# JONES & BEACH ENGINEERS INC.

**RE: Response Letter 4 –TAC Comments**  
**212, 214, & 216 Woodbury Ave., Portsmouth, NH, 03801**  
**Tax Map 175, Lots 1, 2, & 3**  
**JBE Project No. 21254**

We are in receipt of comments from Stefanie Casella, Portsmouth Planning Department, dated December 30, 2022 as well as comments from Eric Weinrieb, Altus Engineering, dated January 11, 2023. Review comments are listed below with our responses in bold.

DRAWING No.	D4
SHEET 15 OF 23	JBE PROJECT NO. 21254

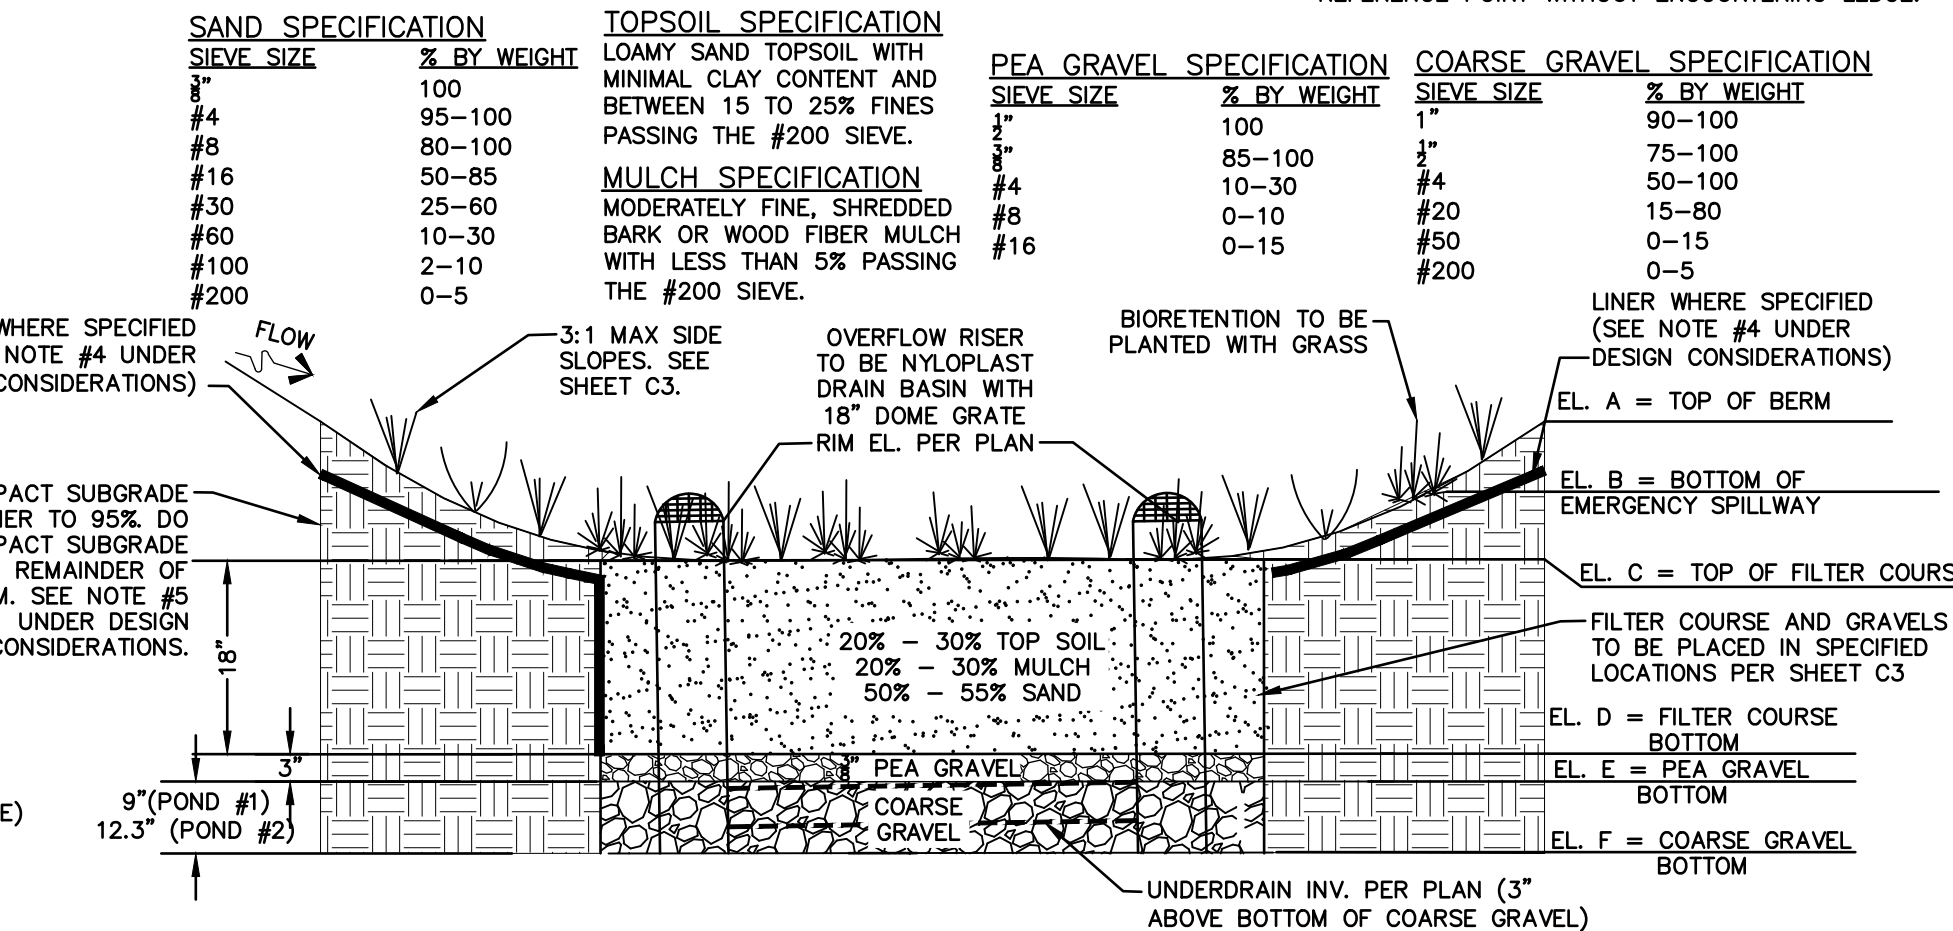
27. *The clay core should be depicted on the spillway detail and should be shown being keyed into the original grade to ensure that lateral movement of water does not occur.*

**RESPONSE: The clay core has been added to the spillway detail and it is noted on the detail that it shall be keyed into original grade to ensure that lateral movement of water does not occur. The bioretention berm section detail on Sheet D4 states the same.**
